THE DRUM MIXER PROCESS FOR VOLUME REDUCTION & SOLIDIFICATION

TOPICAL REPORT
THE DRUM MIXER PROCESS FOR VOLUME
REDUCTION AND SOLIDIFICATION

Subject: Acceptance for Referencing of Licensing Topical Report
JGC-TR-001-P and JGC-TR-001-NP "The Drum Mixer Process
for Volume Reduction and Solidification"

This Amendment presents the answers to the questions prepared in connection with JGC Corporation's Topical Report "THE DRUM MIXER PROCESS FOR VOLUME REDUCTION AND SOLIDIFICATION", Report No. JGC-TR-001-P, November 1981.

Q31. FIG. 6-1 EQUIPMENT LAYOUT (1)

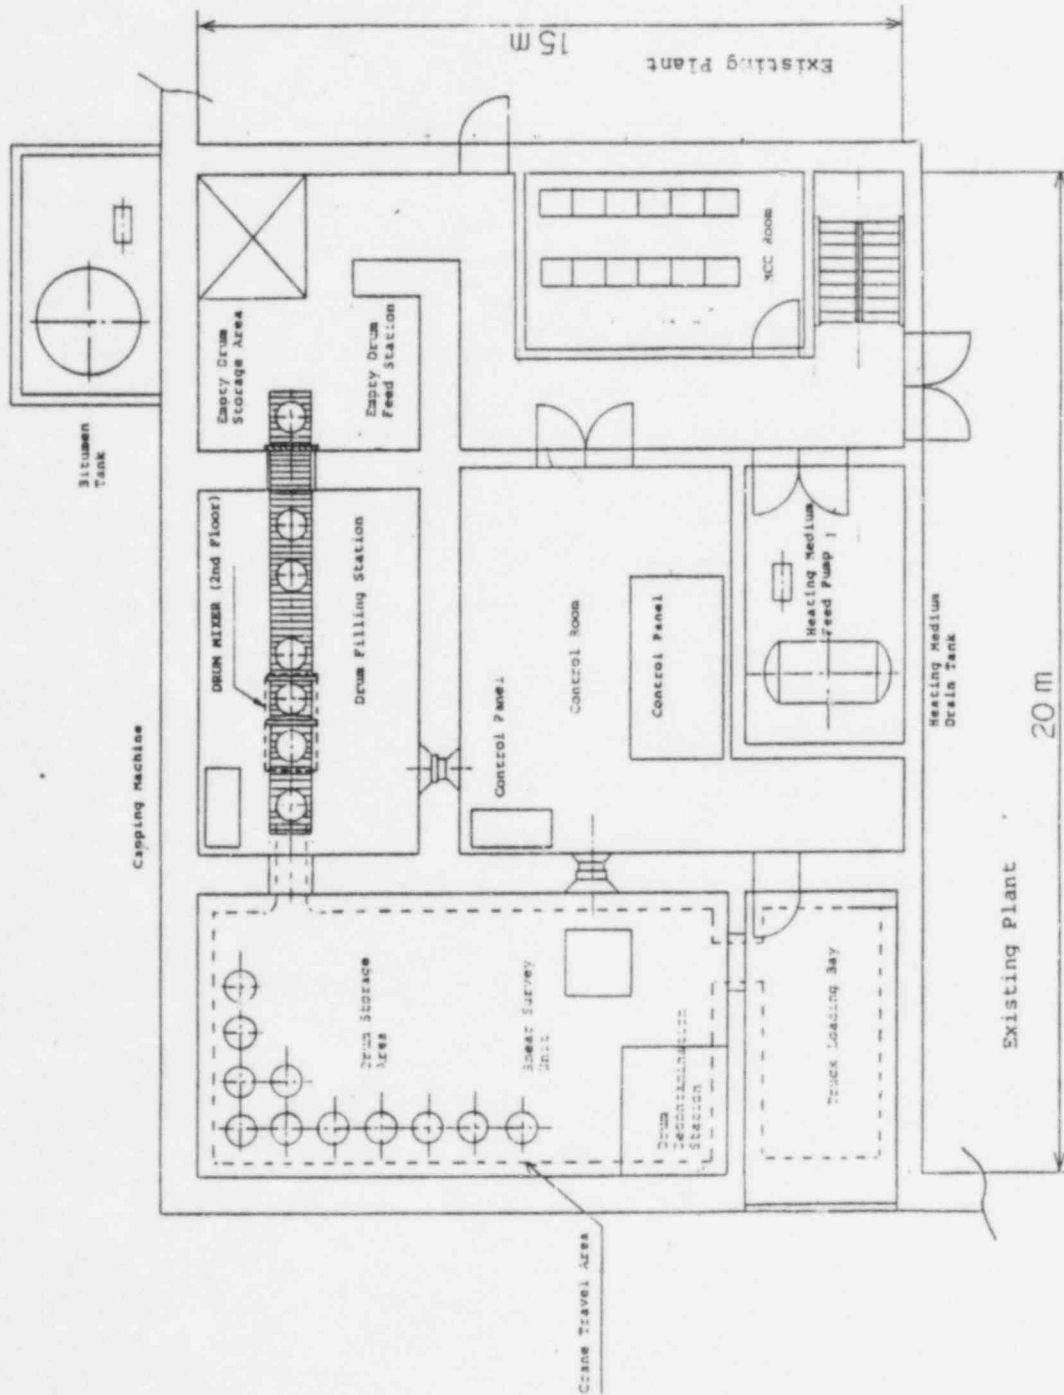
Indicate location of drum-mixer.

In accordance with your comment, JGC indicates it in Fig. 6-1 (1) with a dotted line. Please refer to Fig. 5-1.
